NRC-013

**Combined License
Application Review
William States Lee III
Units 1 and 2
Safety Panel
October 5, 2016**

**Lee Site Foundation
Response Spectra
(WLS DEP 2.0-1)**

Lee Site Foundation Response Spectra

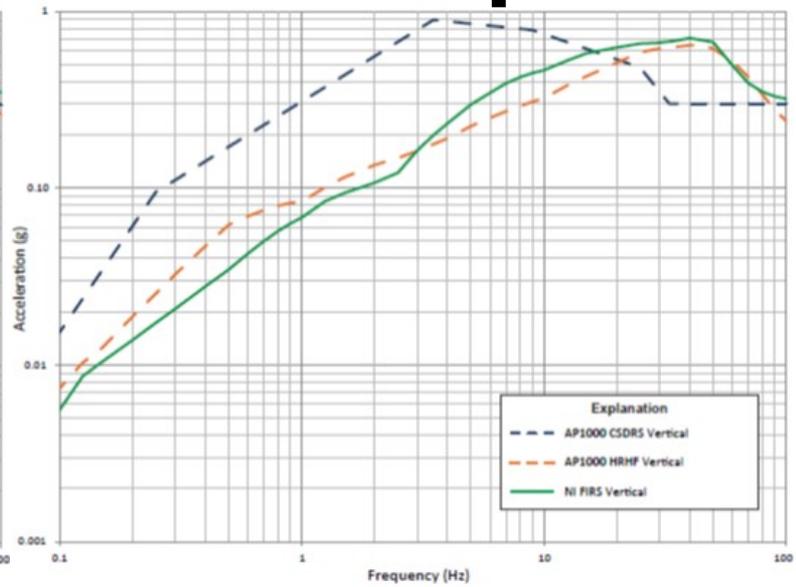
- **Exceeded the AP1000 CSDRS and HRHF spectra in the high frequency range.**
- **Required site-specific seismic evaluations of SSCs per the AP1000 DCD.**

- **Site-specific evaluation was performed to demonstrate the high frequency exceedance is non-damaging.**
- **ISRS at DCD defined locations showed small exceedances.**
